RE: Hennepin East Pond 2 and Addendum Closure/Post-Closure Plan

RE: Response to IEPA's May 2, 2019 Comment Letter on both the Closure / Post-Closure Plan for the Hennepin East Ash Pond No 2 and the Closure Plan Addendum Hennepin East Ash Pond 2

**RE:** Response to IEPA Comments – Closure and Post-Closure Care Plan for the Hennepin East Ash Pond No. 2, and Closure Plan Addendum Hennepin East Ash Pond No. 2 which includes closure of Ash Pond No. 4

RESPONSE TO IEPA COMMENTS  
 EAST ASH POND NO. 2  
 DYNEGY MIDWEST GENERATION, LLC  
 HENNEPIN POWER STATION, HENNEPIN, ILLINOIS

COMPARISON OF OBSERVED AND MODELED CONCENTRATIONS, OBSERVED AND MODELED HEADS, AND OBSERVED CONCENTRATION VERSUS OBSERVED HEAD BY WELL LOCATION

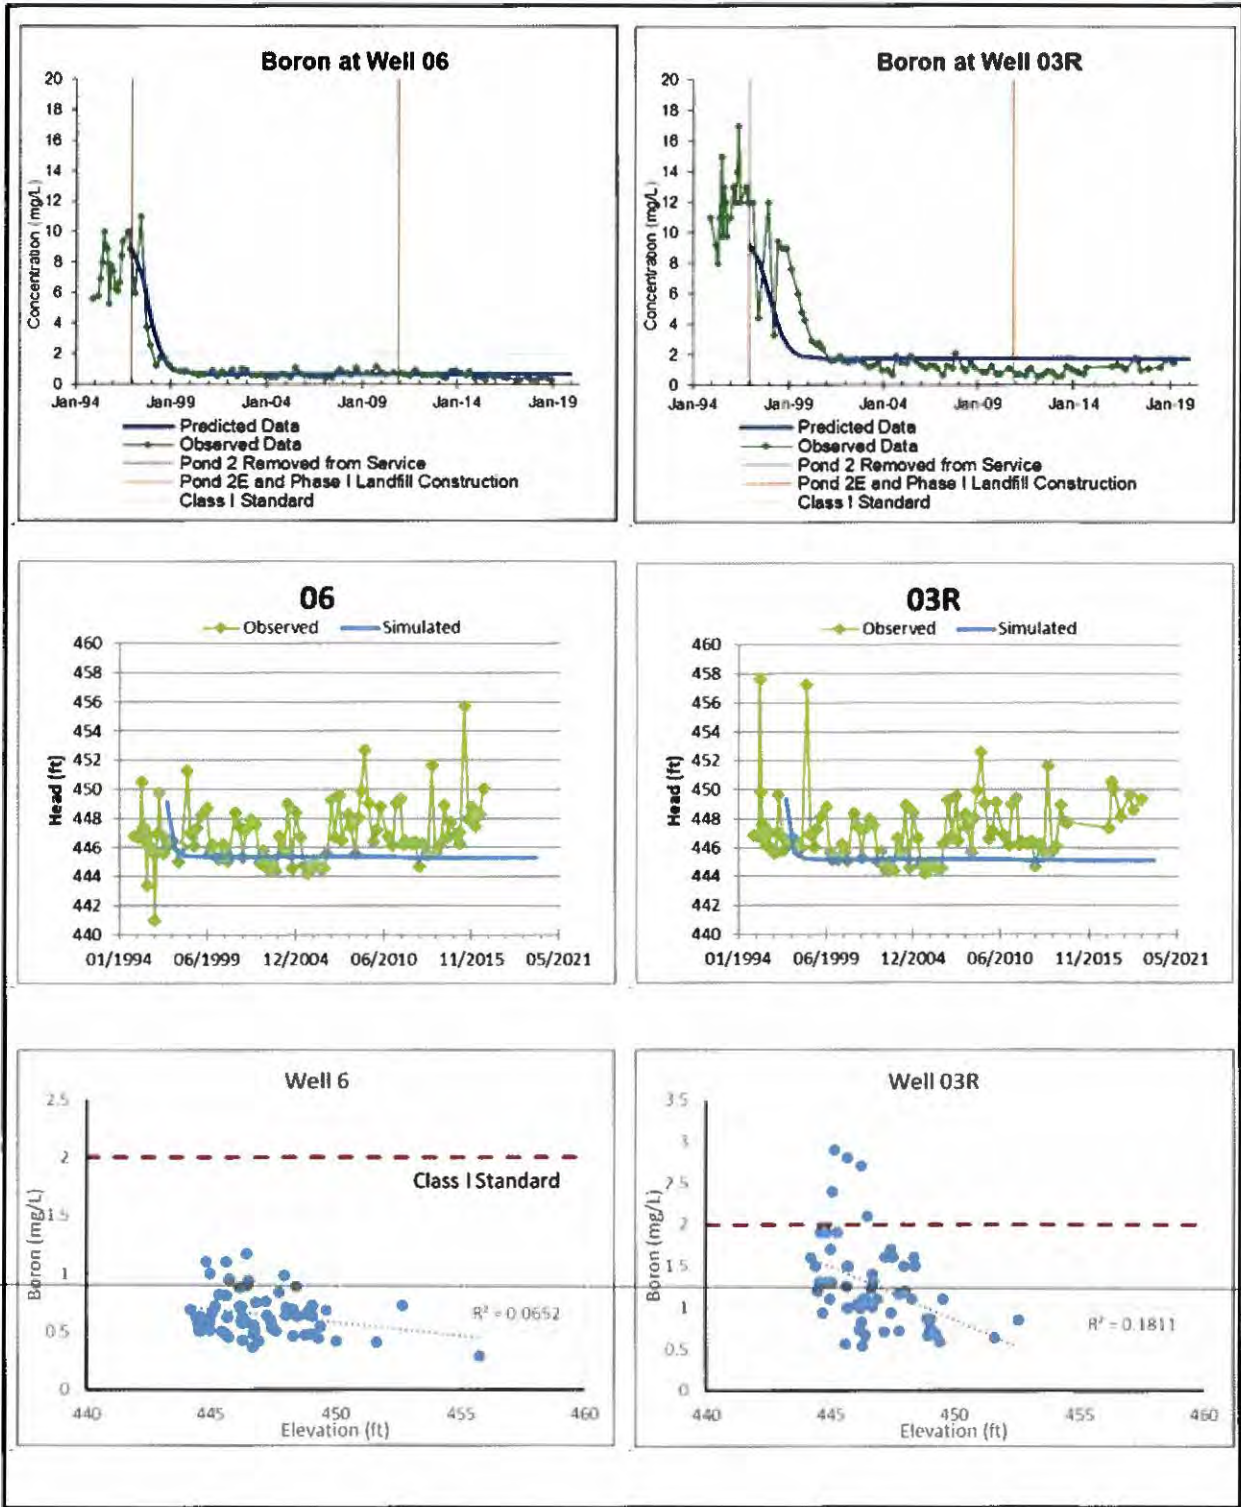
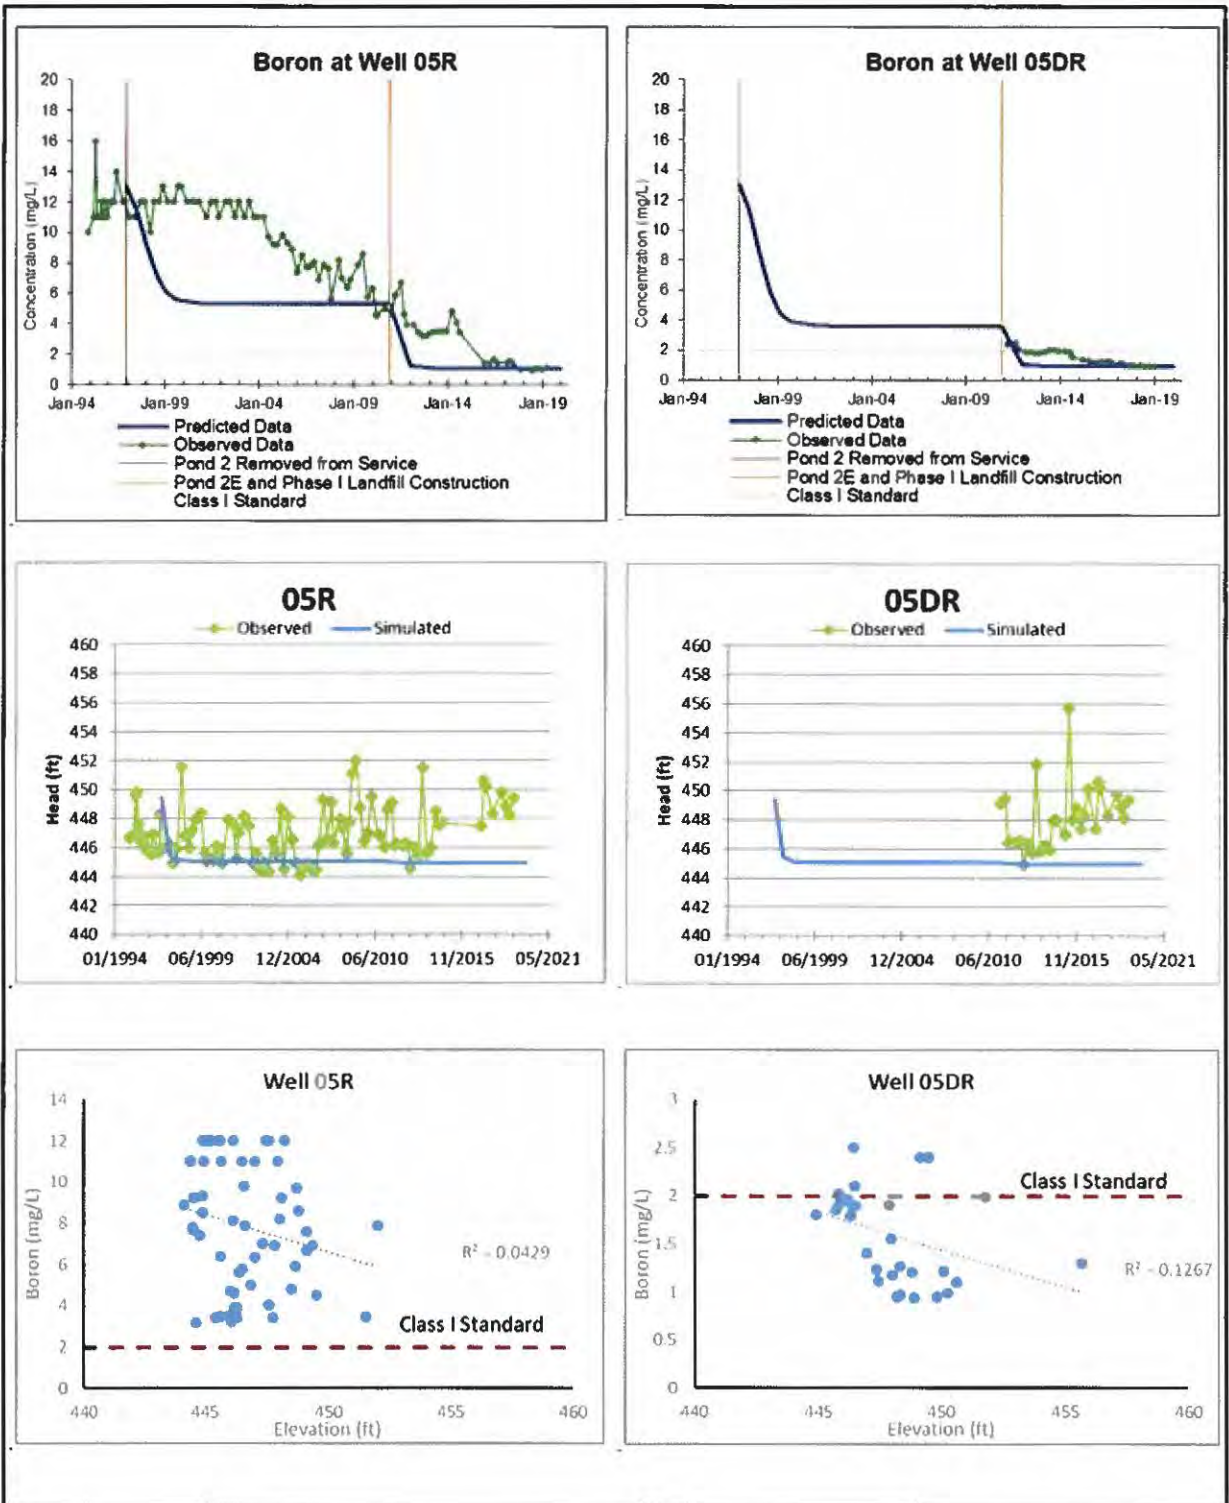
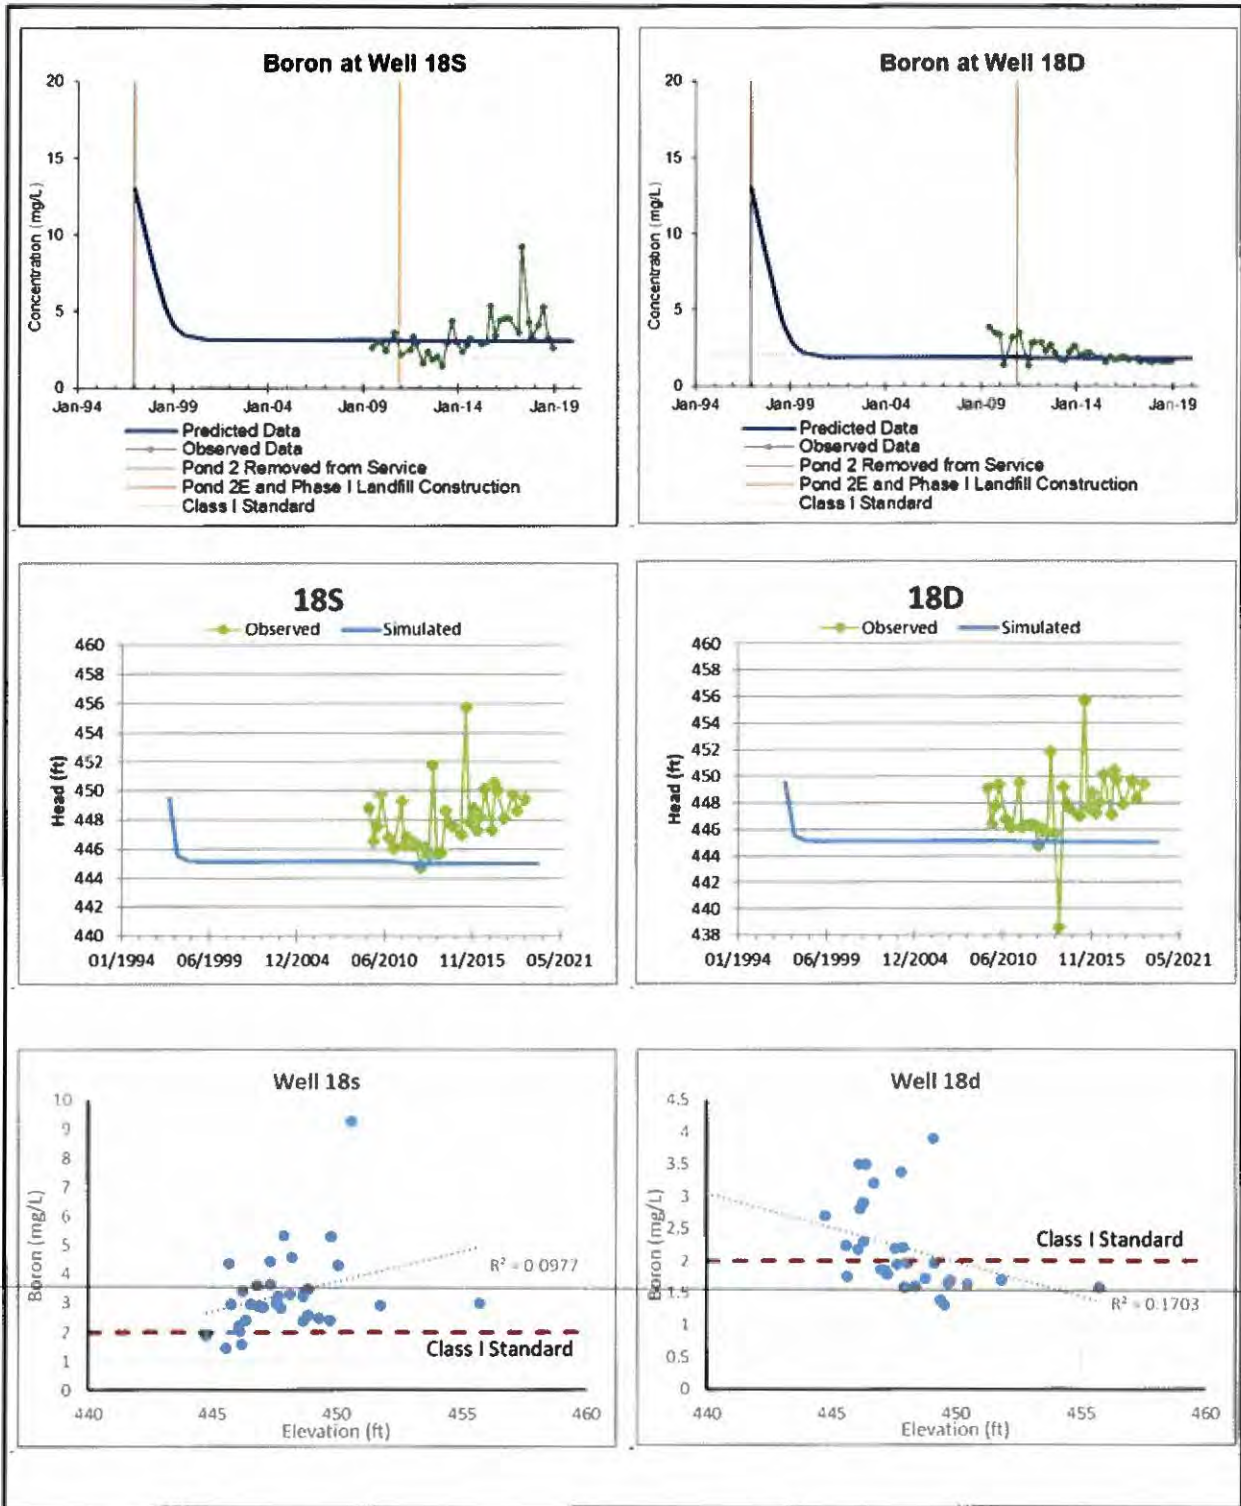
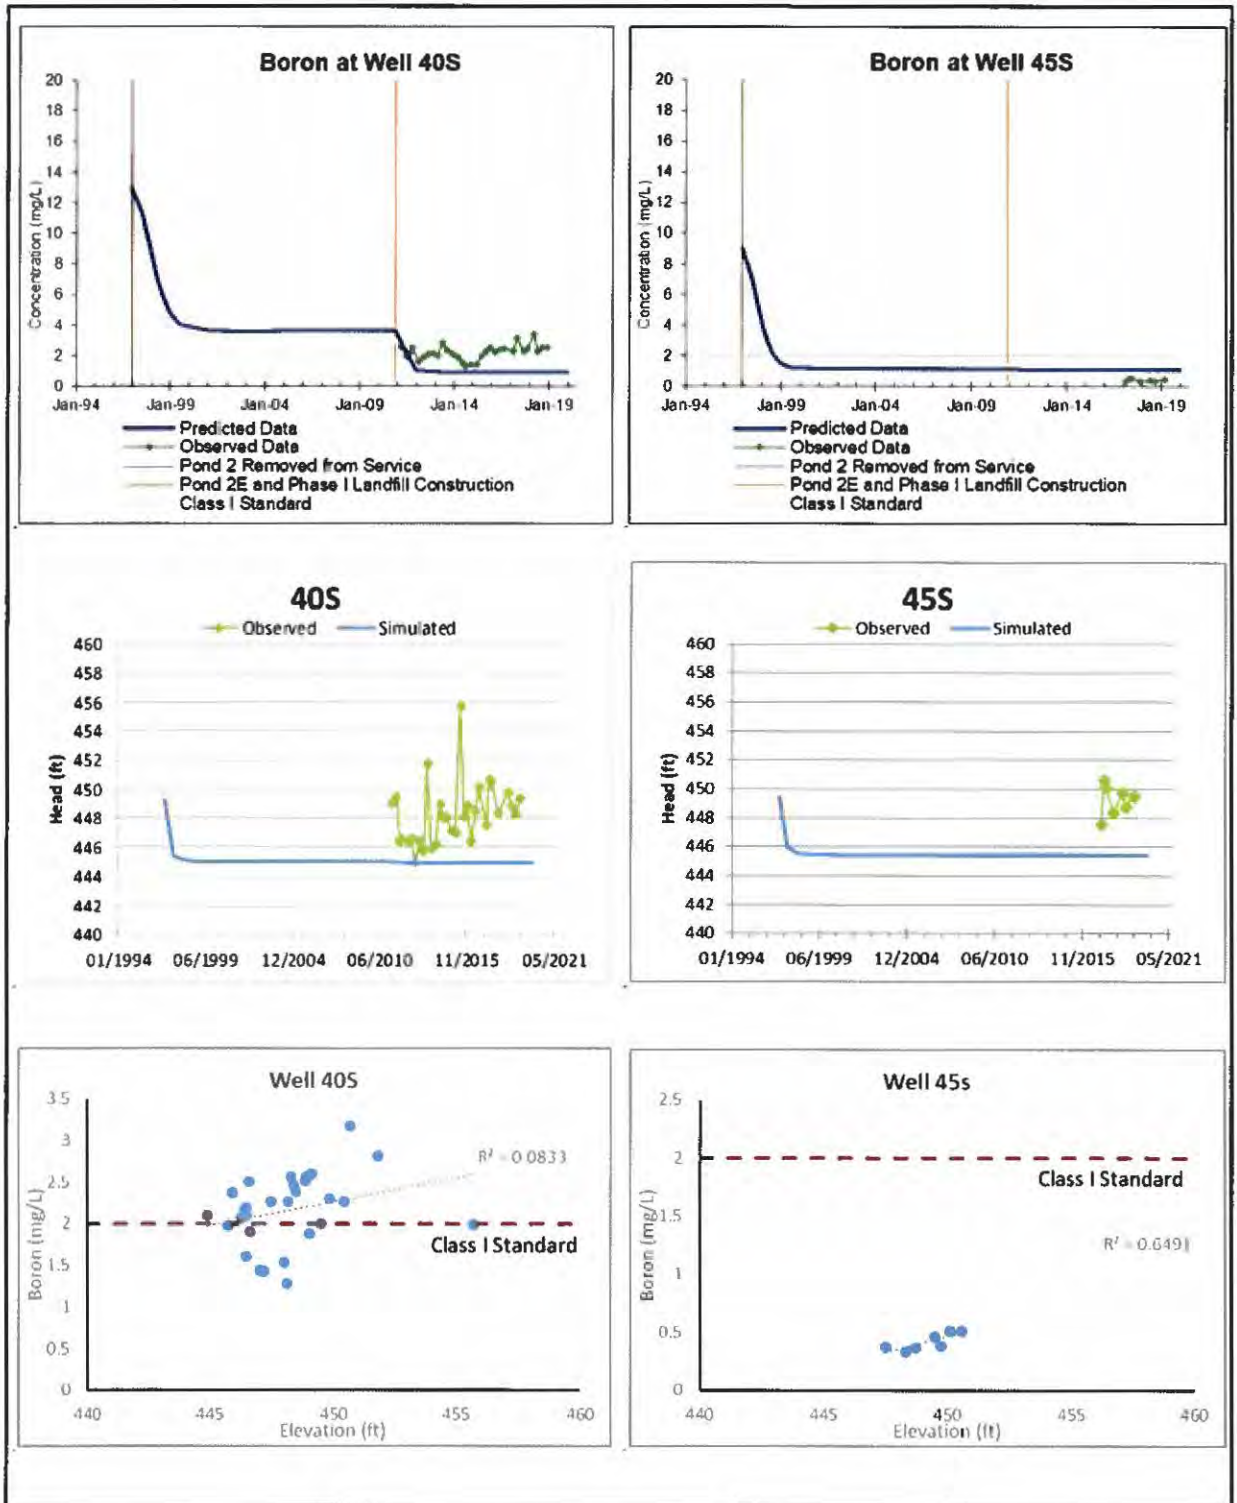
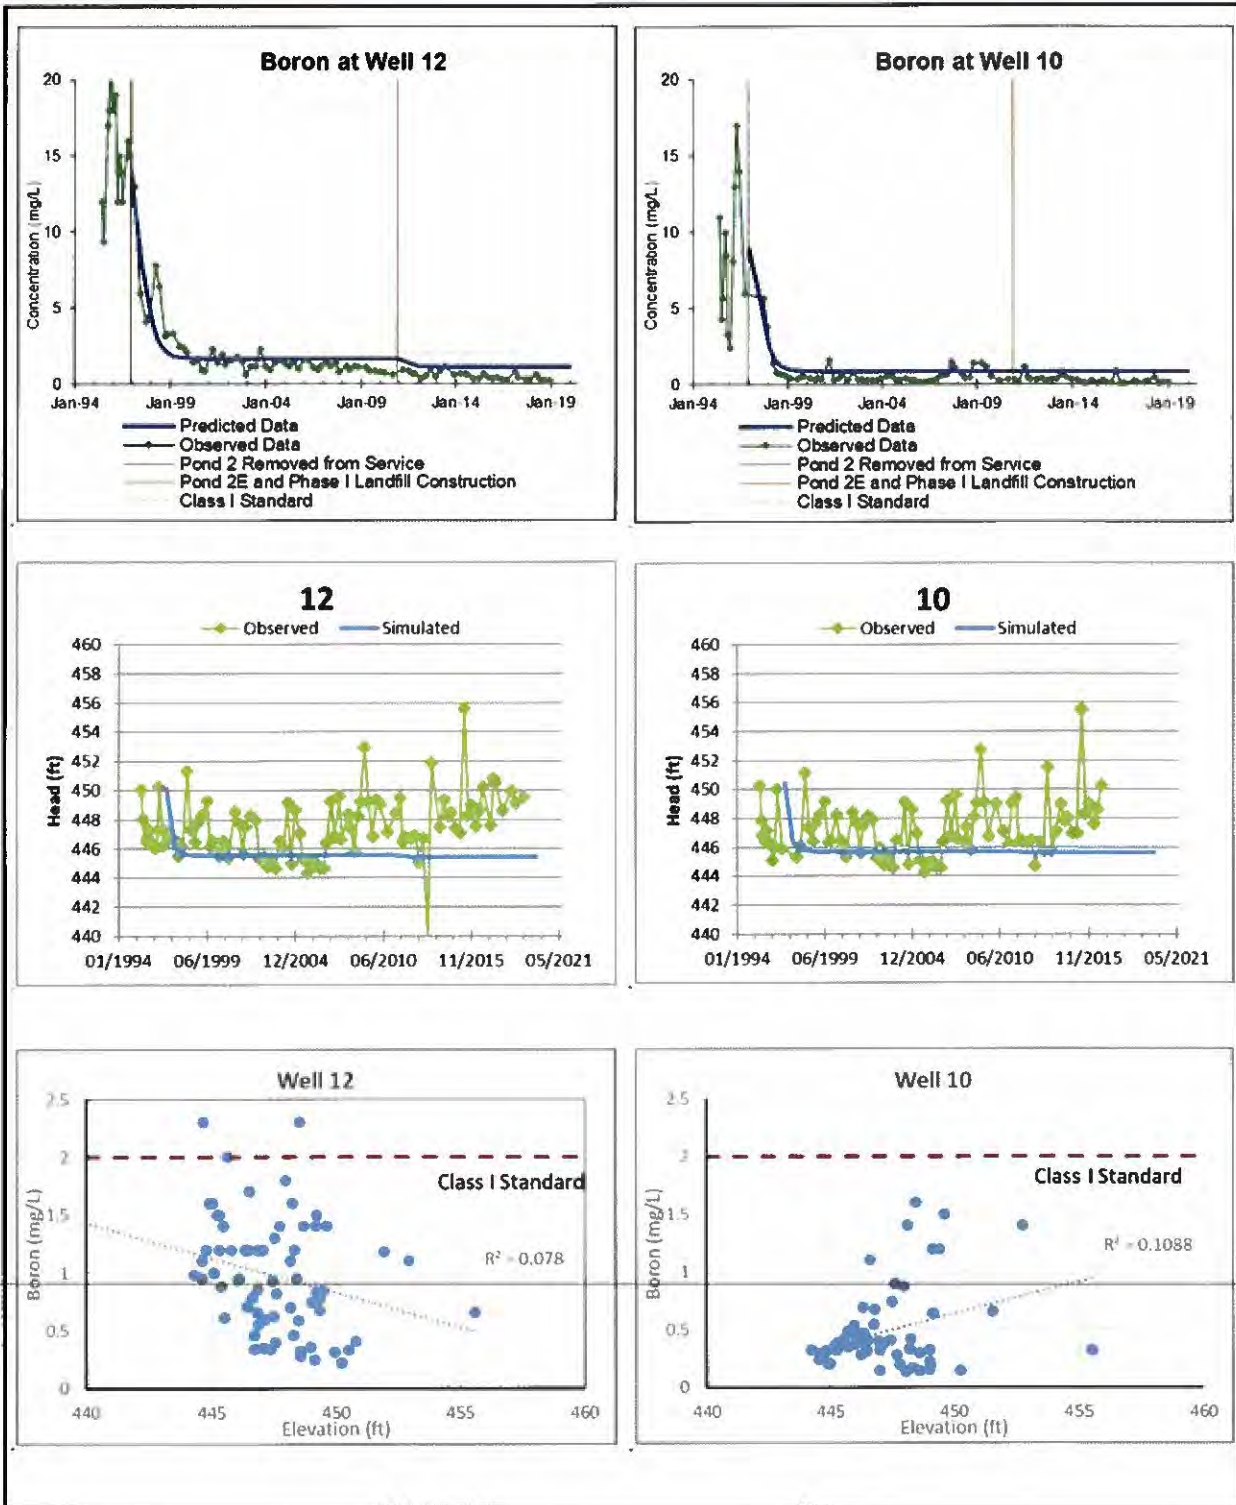
*Please provide additional discussion of the probable impact that occasional inundation of ash during flood events will have on predicted Boron, Lithium and Molybdenum concentrations (also see Comment 11).*

conditions to the Illinois River. Observed concentrations at 5R tend to lag behind predicted concentrations as compared to the other downgradient wells 06 and 03R (Figure 1); however, the observed concentrations are decreasing over time to match long-term predictions. Wells 10, 12, and 13 also have over 20 years of data with observed and predicted concentrations matching very well.

The relationship between groundwater elevation and concentration has further been evaluated by comparing observed groundwater concentration to observed groundwater elevations in Figure 1. Trend lines and coefficient of determination values ( $R^2$ ) have also been provided. The correlation coefficients range from 0.043 to 0.18 for wells with 10 or more data points. Well 45S has a correlation coefficient of 0.65 with seven data points and boron concentrations are below the applicable groundwater standard. The low correlation coefficients in observed data indicate that the boron concentration is not strongly related to higher or lower groundwater elevations. Flooding (and short-term groundwater elevation increases) may occasionally coincide with increases in boron concentration; however, they do not correlate on a regular basis, nor do they cause deviations from long-term concentration trends as discussed above.
